## Landmark Commission Agenda

### Monday, December 7, 2020

Figure 27 -- Proposed site plan.

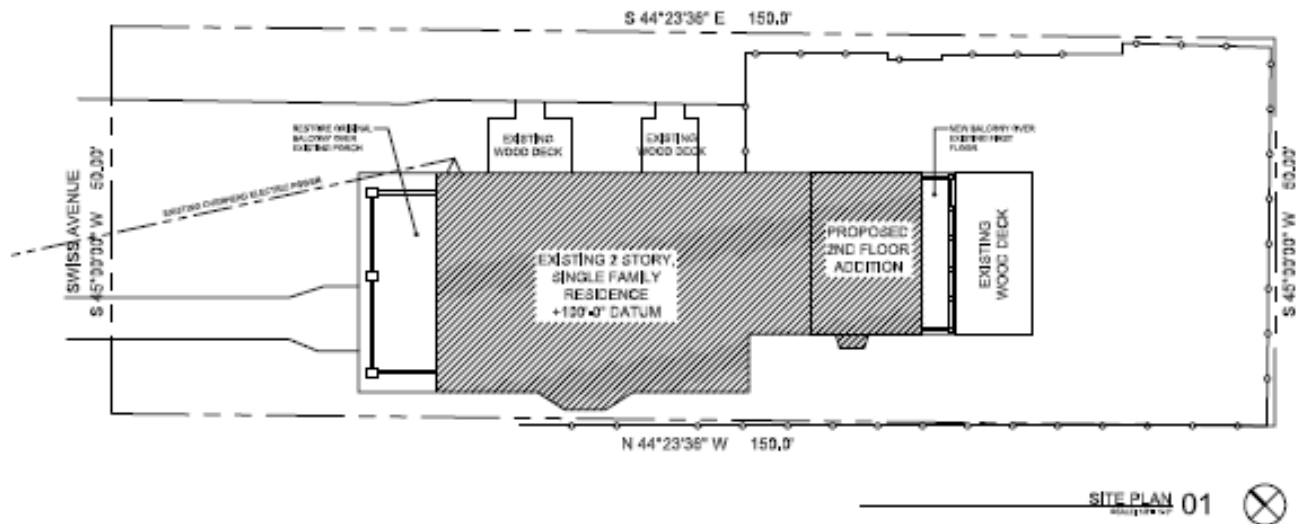
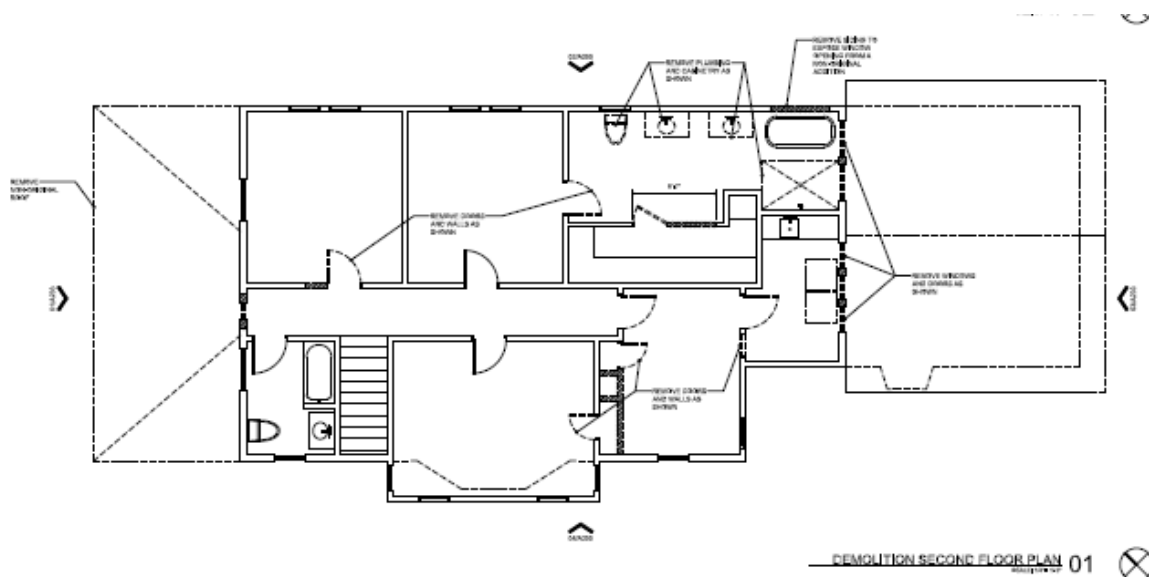
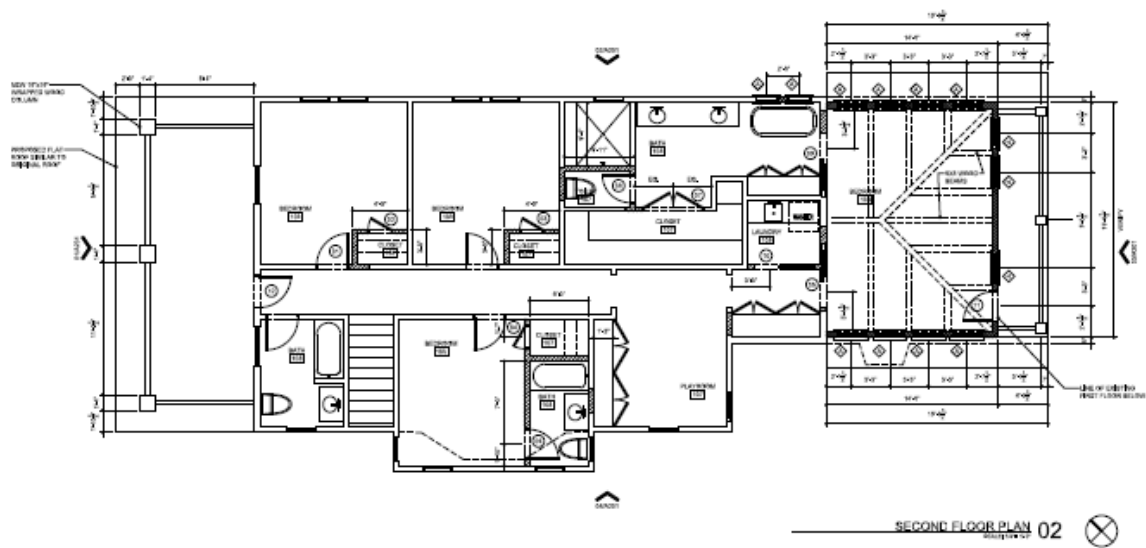
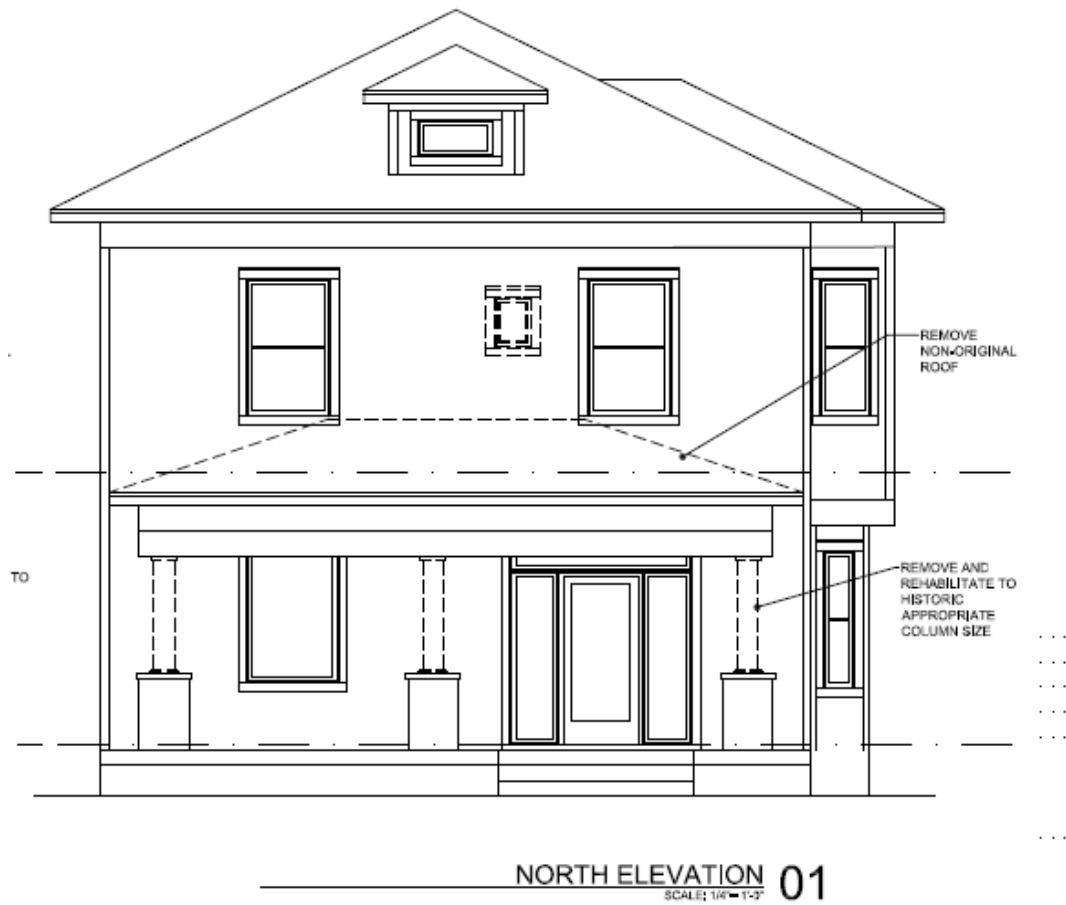
The 1921-1927 and 1921-1952 Sanborn maps (Figures 20 and 21) show the original structure to have had a single story porch. Had the original structure included a second story porch, it would have been recorded on the Sanborn maps; a decorative balcony, however, is unlikely to have been noted since Sanborn maps were concerned with footprints, number of stories, and materials for the purpose of assessing fire hazards and setting insurance rates. Furthermore, true second story porches are not commonly seen on Prairie houses, yet decorative balconies are found (Figure 25).

Staff is also recommending approval of the work on the columns with the condition that they include recessed panels as seen in Figure 26.
